RE: Response to NMED's Notice of Disapproval, Remedy Completion Report, Railroad Rack Lagoon (SWMU No.8) Revised Report  
Western Refining Company Southwest Inc., Gallup Refinery  
EPA ID # NMD000333211 HWB-GRCC-06-001"

**FIGURE 1**  
**RAILROAD RACK LAGOON EXCAVATION/CONFIRMATION SAMPLE LOCATIONS**  
**WESTERN REFINING COMPANY GALLUP REFINERY GALLUP, NEW MEXICO**

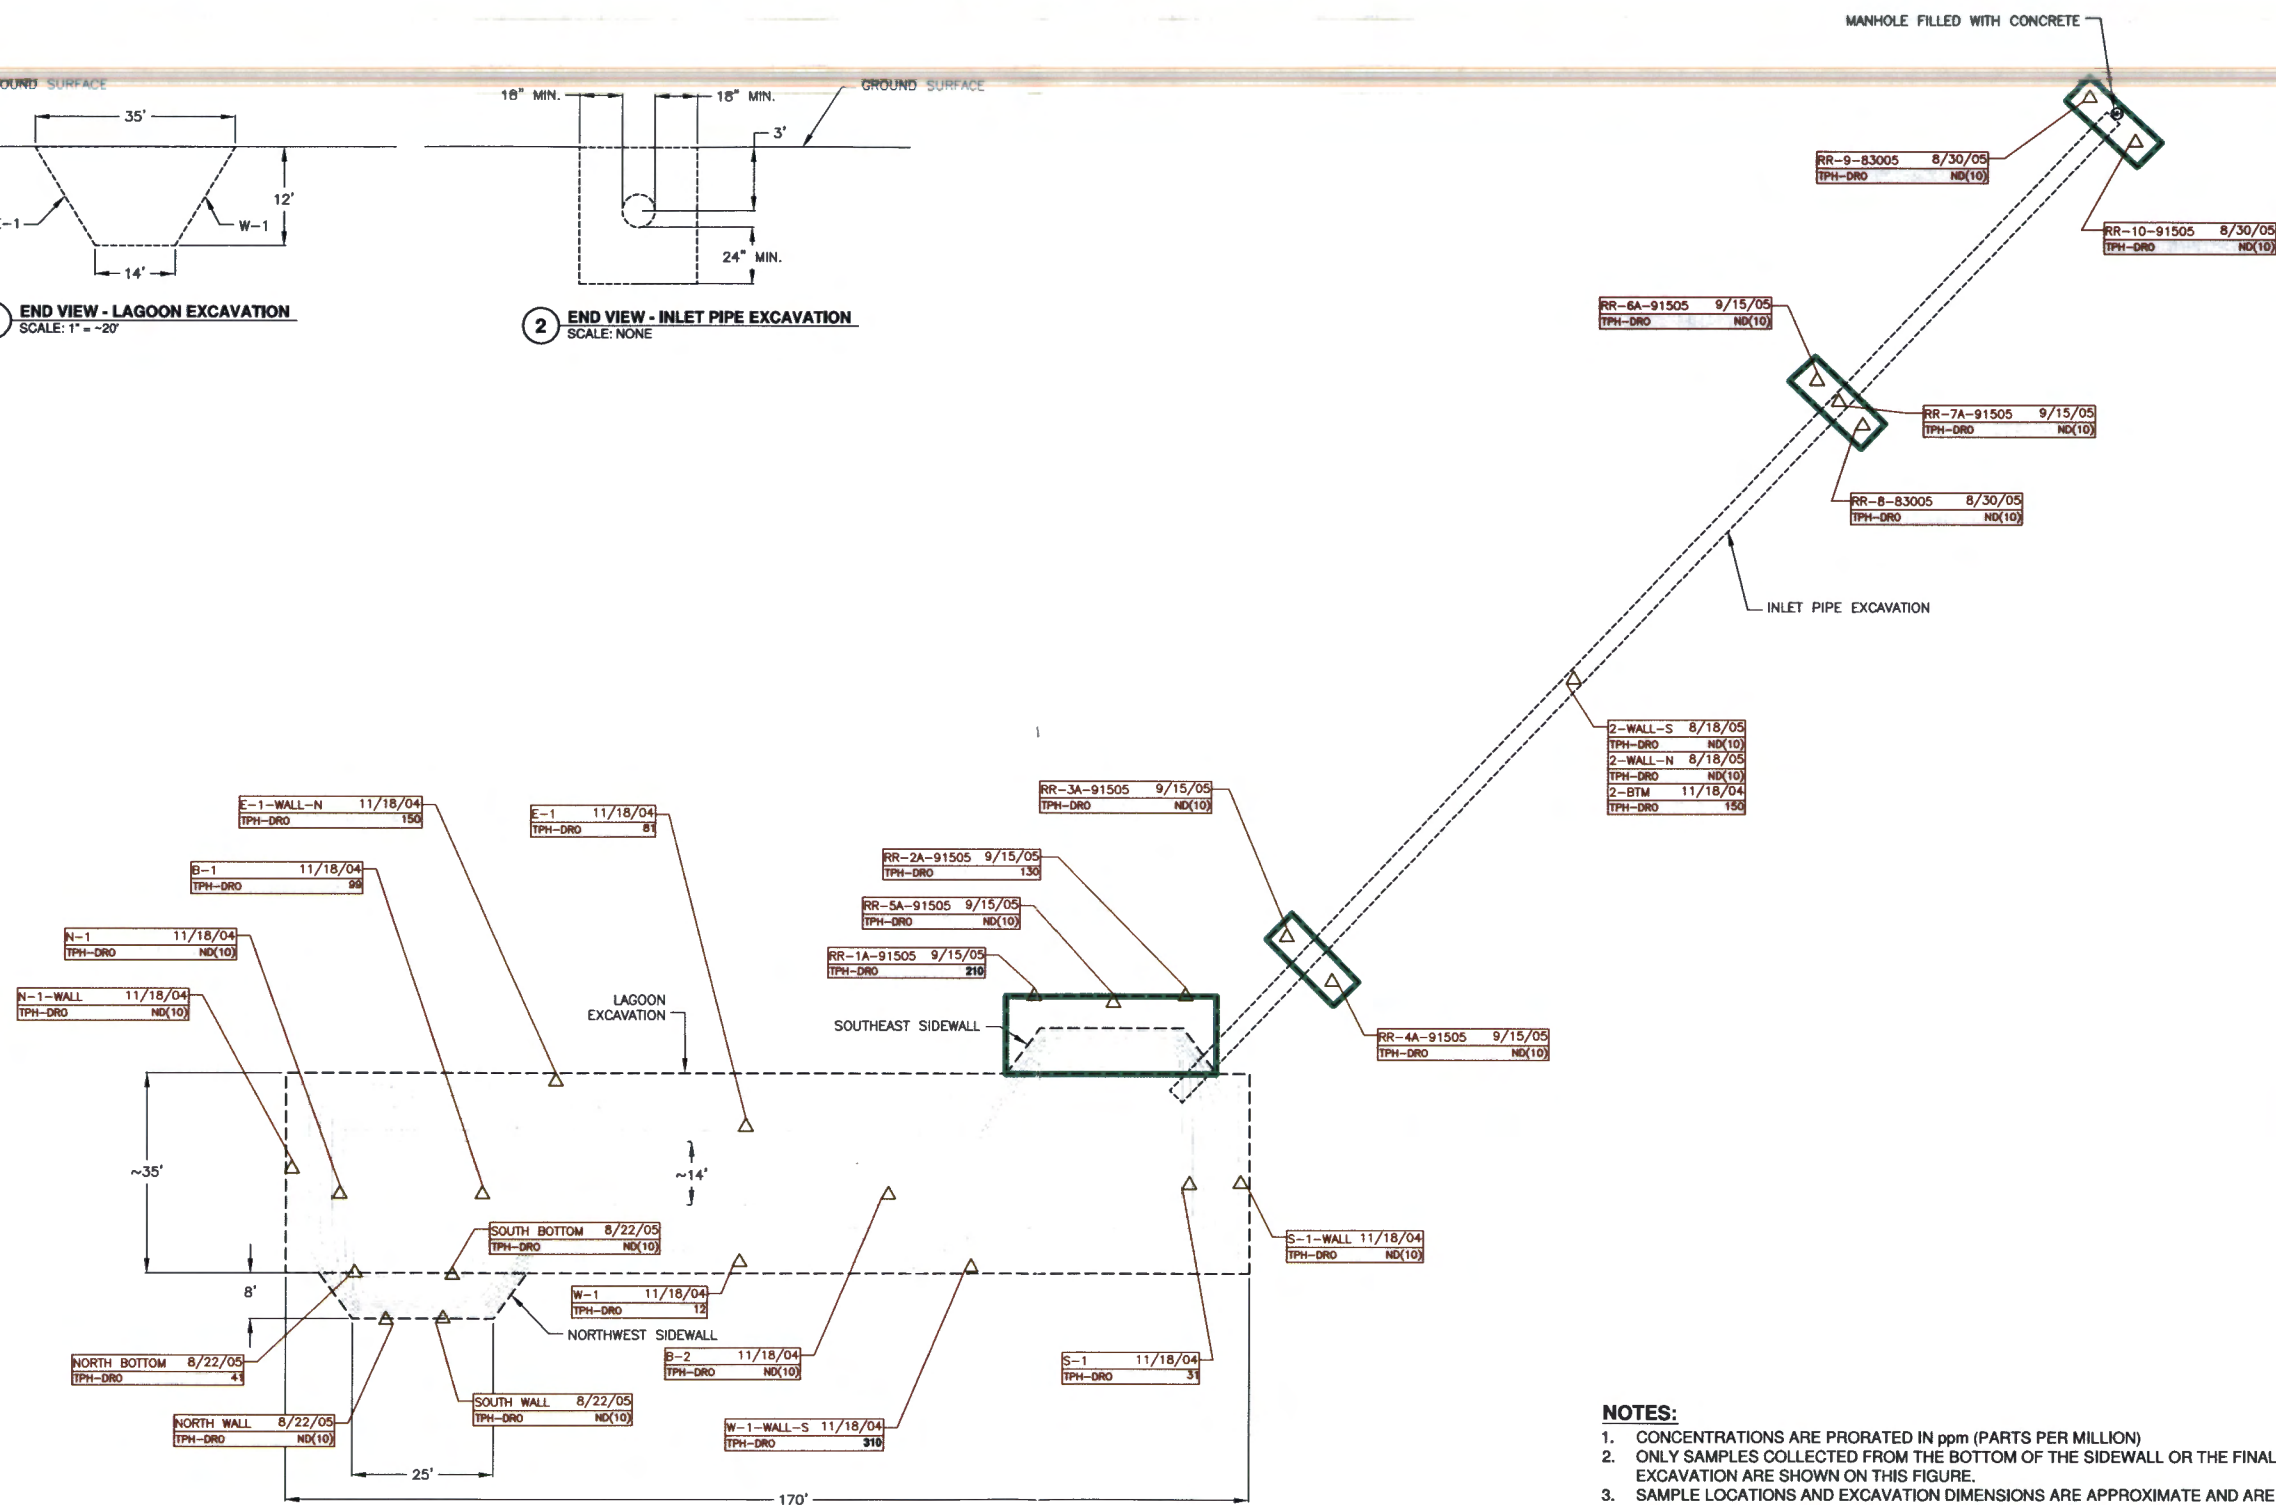
The final dimensions (including all of the additional excavations and the excavation of the piping) are not clearly presented in the Report. The Permittee must present the excavation dimensions and provide a figure showing the dimensions and the locations of the final confirmation samples. The Permittee must demonstrate that the excavation of contaminated soil is complete.

The Permittee was required to excavate soil to residential/industrial levels of DRO (200mg/kg); DRO was detected in one of the confirmation samples, RR-1A-91505, located along the north wall of south-east sidewall excavation of the pipeline at a concentration of 210 mg/kg. The Permittee must complete a boring from undisturbed native soils within 2 feet of the original sample location. Samples must be collected from the ground surface and at two-foot intervals to a depth of ten feet below the ground surface for a total of five samples. Samples sent to the laboratory for analysis must be the most contaminated samples based on field observations (e.g., odor, color), and from the total depth of the boring. The results of the sampling must be included in the supplemental report (see also Comment 1). If the samples contain concentrations of DRO that exceed the clean-up standards, additional excavation will be required. The Permittee must note that in order to meet the requirements of corrective action complete without controls, all confirmatory soil samples must be at or below the NMED cleanup levels (see *Technical Background Document for Development of Soil Screening Levels, Revision 5.0*, which is available online at [http://www.nmenv.state.nm.us/hwb/documents/NMED\\_SSG\\_August\\_2009\\_Dec09TableA-1\\_clean.pdf](http://www.nmenv.state.nm.us/hwb/documents/NMED_SSG_August_2009_Dec09TableA-1_clean.pdf)).

Please see the enclosed Figure 1 (dated 12/28/10) showing the dimensions and locations of the final confirmation samples.

Upon further clarification in a letter from the NMED HWB dated December 17, 2010, Western Refining would like to seek corrective action complete without controls for the lagoon area. Western would like to request until March 1, 2011 to conduct the boring and sampling near RR-1A-91505 needed to comply with Comment 3. Western will also conduct a similar boring and sampling at sample location W-1-WALL-S which indicated a DRO of 310 mg/kg as shown on Figure 1.
